**NRC Conference Call (5/15/07)**  
**Steam Generator Tube Inspection Discussion Points**  
**Oconee Nuclear Station, Unit 2**

S/G A  
 PRIMARY FACE  
 INLET  
 TOTAL TUBES: 15631  
 TUBES SELECTED: 1587  
 OUT OF SERVICE (#): NA

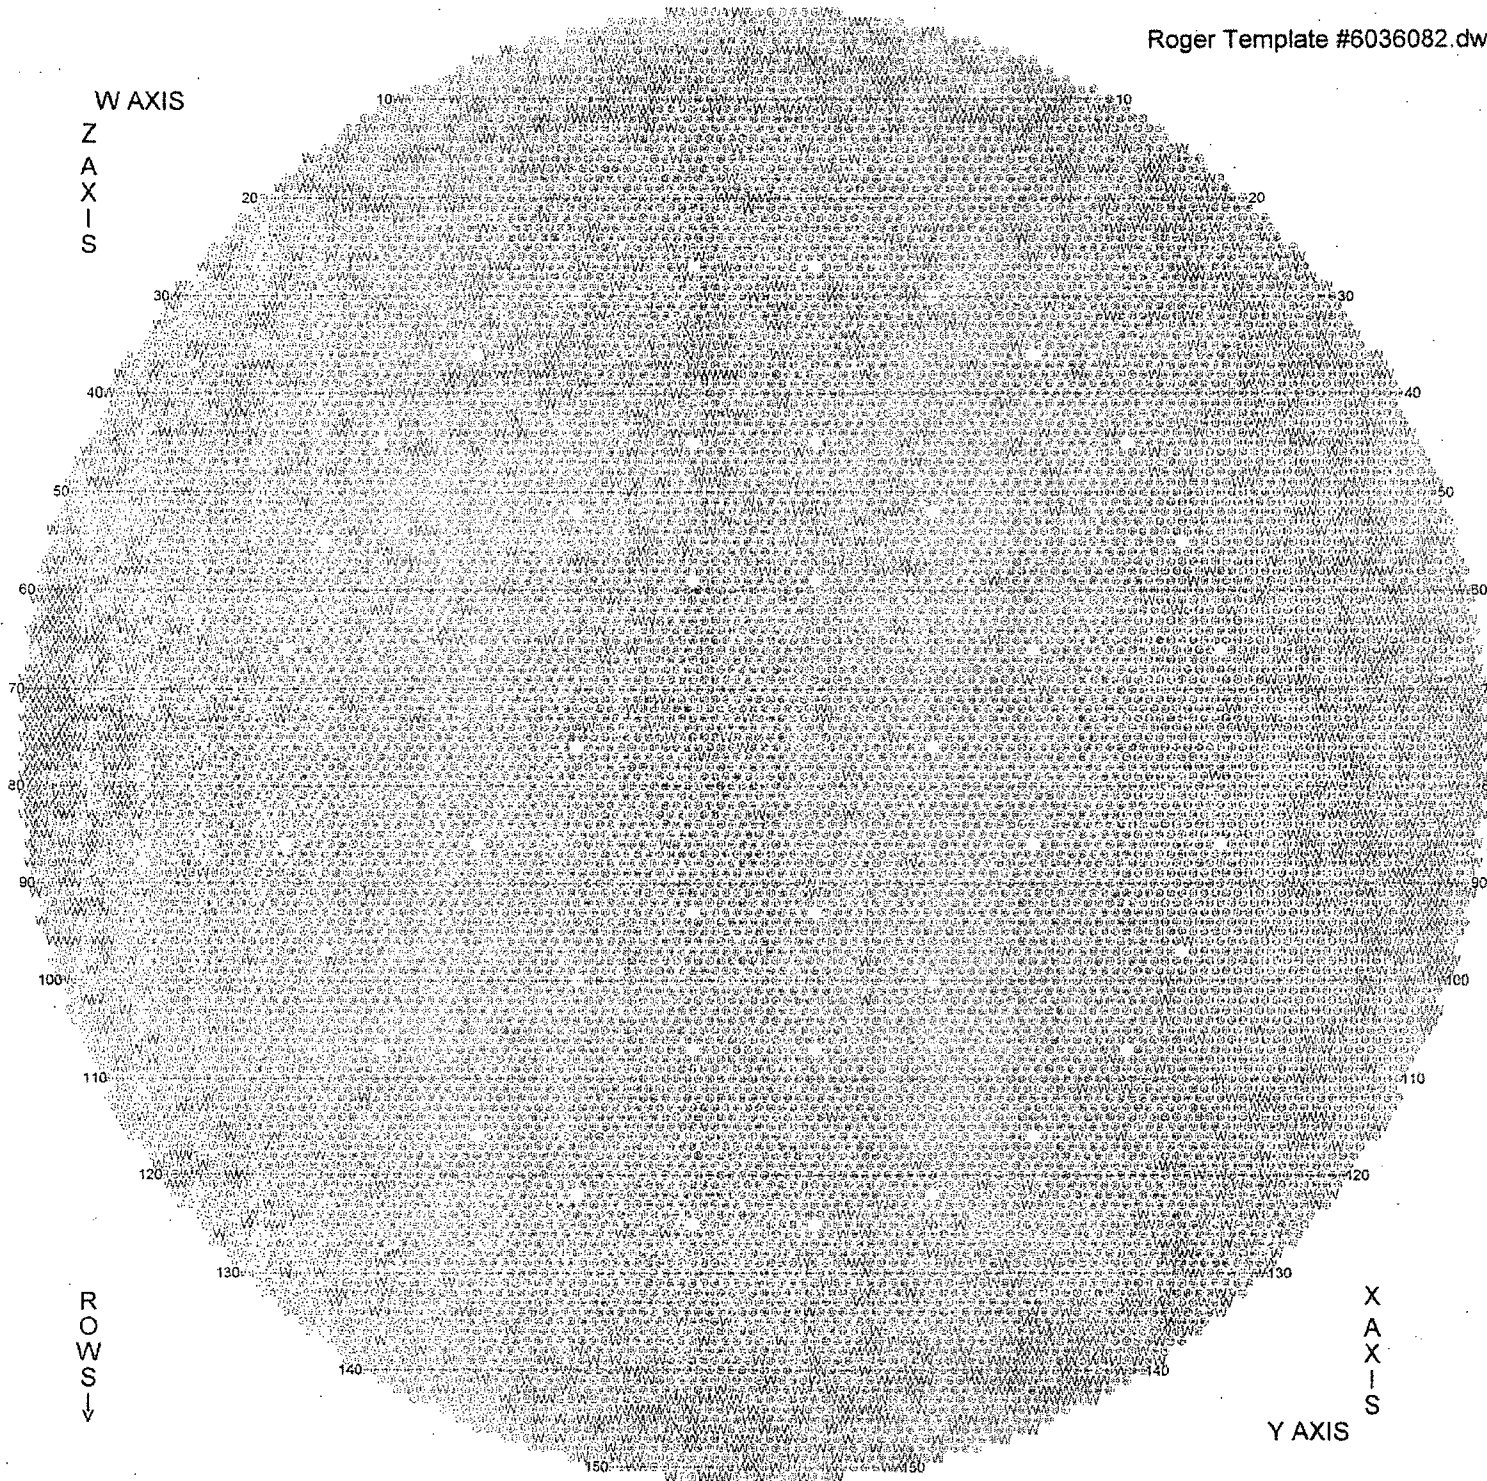
SG B – The inspection on the 2B steam generator is complete. See Attachment A for a summary of results and comparison to previous Unit 2 inspection results.
